UNITED STATES  
NUCLEAR REGULATORY COMMISSION  
WASHINGTON, D. C. 20555

PROPOSED SUBJECTS OF DISCUSSION FOR THE  
NRC-LICENSEE-FUEL VENDOR MEETING ON  
PRAIRIE ISLAND SPENT FUEL FAILURE

TO: <i>Don De Lanna</i>	OFFICE: <i>NOC</i>
FROM: <i>Simon Fahn</i>	OFFICE: <i>NOP</i>
SUBJECT: <i>DROPPED FUEL ELEMENT AT PI</i>	DATE: <i>12-6-82</i>

FIGURE 1  
TOP GRID TO NOZZLE ATTACHMENT

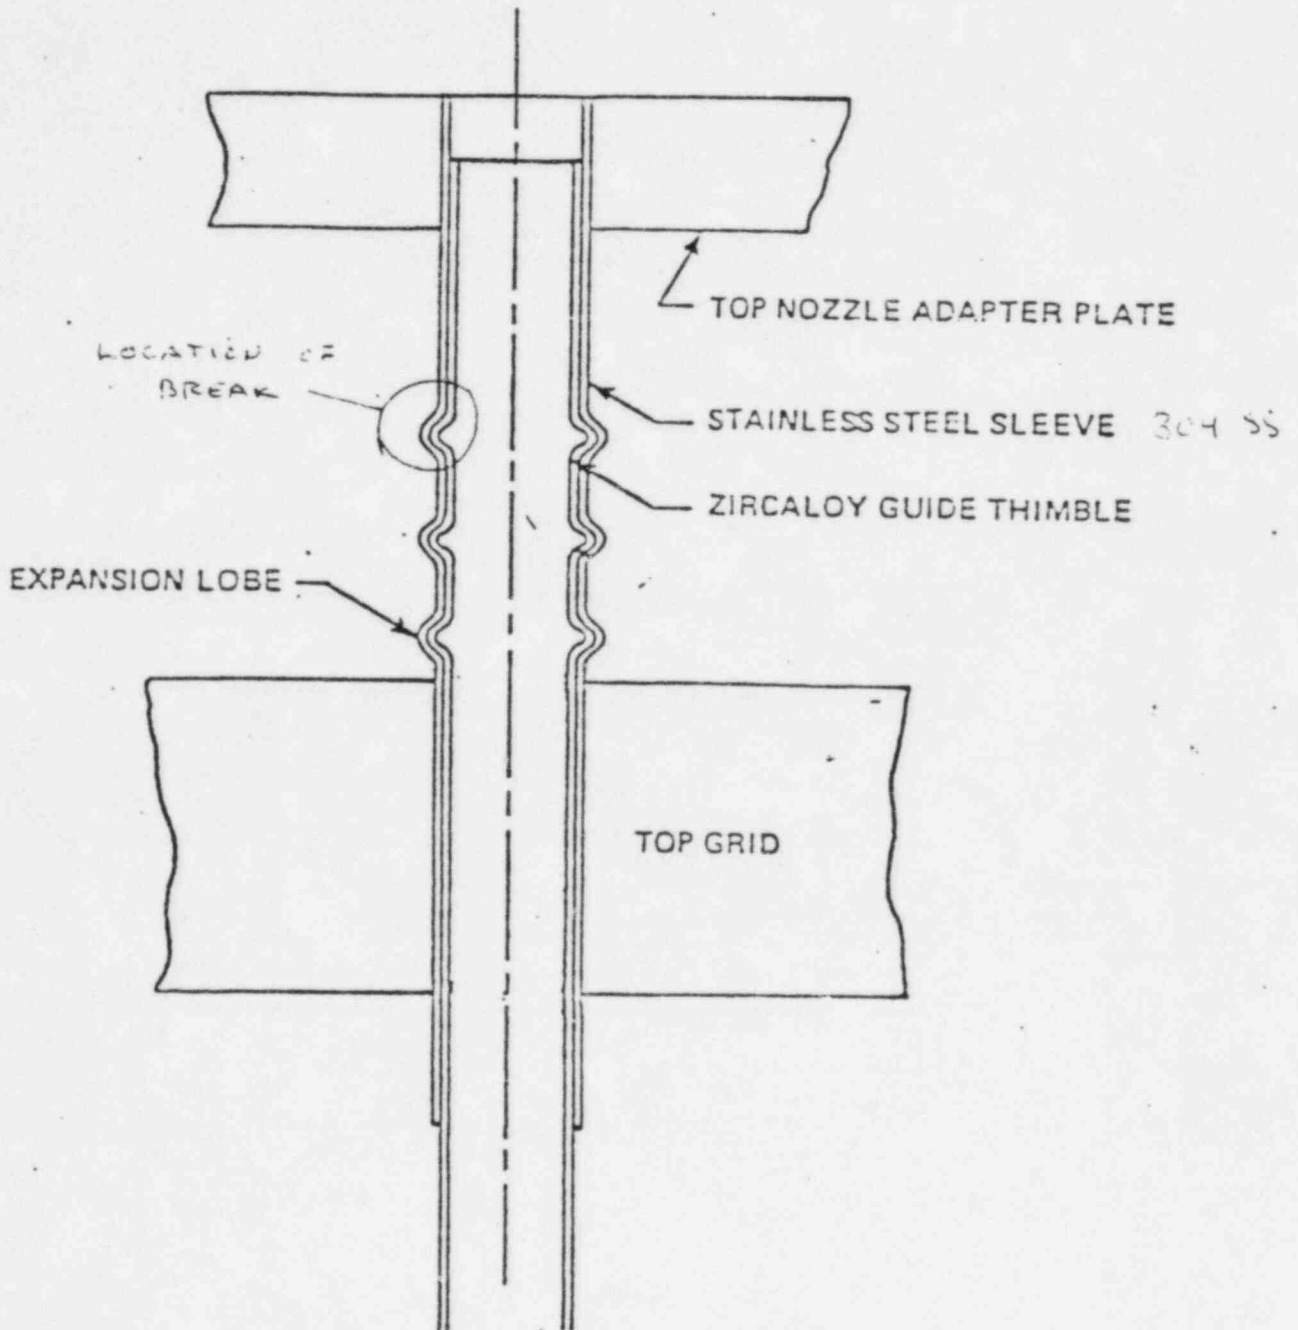
I have enclosed the copy of a typical pin in a fuel element which strikes the top nozzle adapter plate & the fuel element. The newer ~~the~~ fuel elements now have only two injection lobes above the top grid with one below. I hope this was what you were looking for.
